616 NONRADIOACTIVE DANGEROUS WASTE STORAGE FACILITY DANGEROUS WASTE PERMIT
APPLICATION (TSD: S-6-1)

This letter transmits a Notice of Deficiency (NOD) response table and associated revised text for the 616 Nonradioactive Dangerous Waste Storage Facility (NRDWSF) Part B Permit Application (Revision 1) for your review. This information is being transmitted in response to a letter received from the State of Washington Department of Ecology on August 30, 1990, and to discussions held at a October 23, 1990, unit managers meeting. A verbal agreement was reached with Ecology at this unit managers meeting that a NOD response table addressing unresolved comments and the associated draft text would be provided to Ecology for review at the next unit managers meeting scheduled for November 29, 1990.

THE 616 NONRADIOACTIVE DANGEROUS WASTE
STORAGE FACILITY NOD RESPONSE TABLE (REV. 1)
(UNRESOLVED COMMENTS)

Figure 2-2. The 616 Nonradioactive Dangerous Waste Storage Facility Organizational Chart.

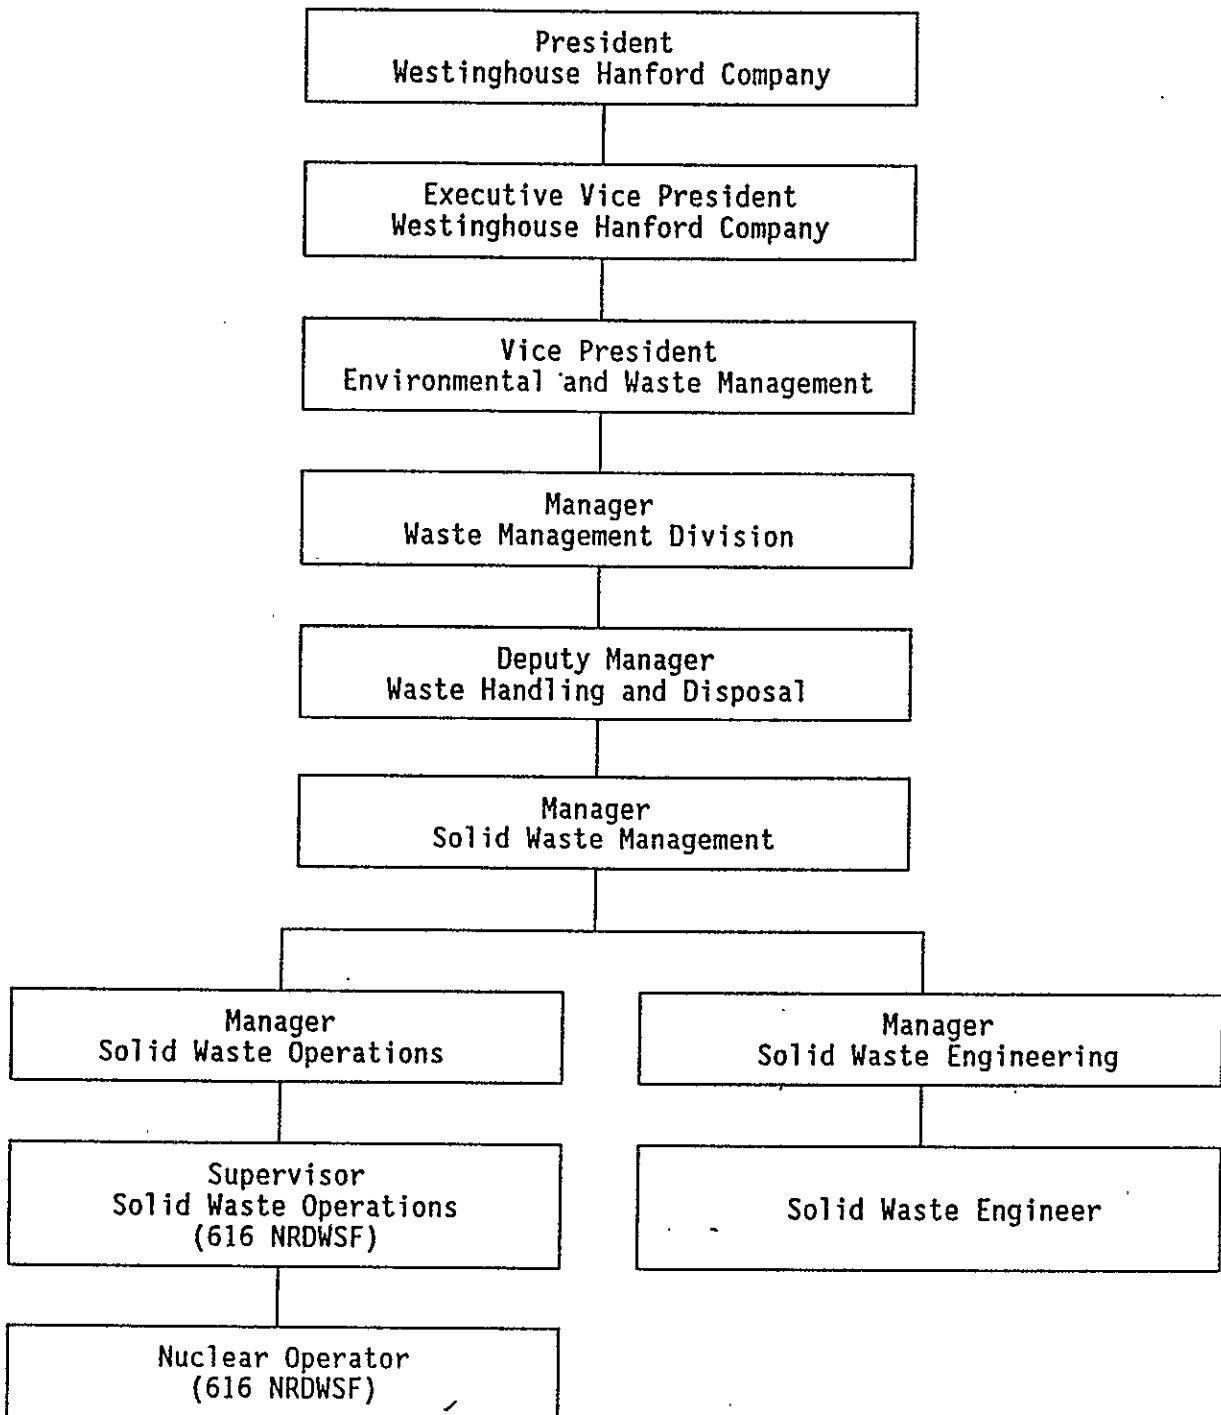
Ecology Requirement: Please clarify 'staff.'

DOE-RL/WHC Response No. 1: The TSD technical staff (assigned to the 616 NRWWSF) provides waste designation guidance to various site generators (see response to comment number 18). The text will be modified to clarify 'staff.'

No.	Comment/Response	Ecology Concurrence
19.	<p>(Cont'd)</p> <p>DOE-RL/WHC Modified Response: The TSD technical staff has been more specifically identified as the Solid Waste Engineering staff. The text has been modified to indicate that the Solid Waste Engineering staff performs an oversight function, independent from the generating units.</p> <p>Page 3-4. The organizational responsibilities of the 'staff' still are not clear. For example, the generating unit's waste coordinator is overseen by Solid Waste Engineering, but it is not stated if the waste coordinator is part of the generating unit's personnel or Solid Waste Engineering's personnel.</p> <p><u>Ecology Requirement:</u> Clarify the organization and responsibilities of the various Hanford Facility staff involved in the handling of dangerous waste from generation through transport to TSD. Include an organization chart indicating which staff at the 616 NRDSWF are responsible to which organizations.</p> <p>DOE-RL/WHC Response No. 2: The text has been modified to clarify organizational responsibilities.</p>

Add the following organizational charts to Chapter 2.0
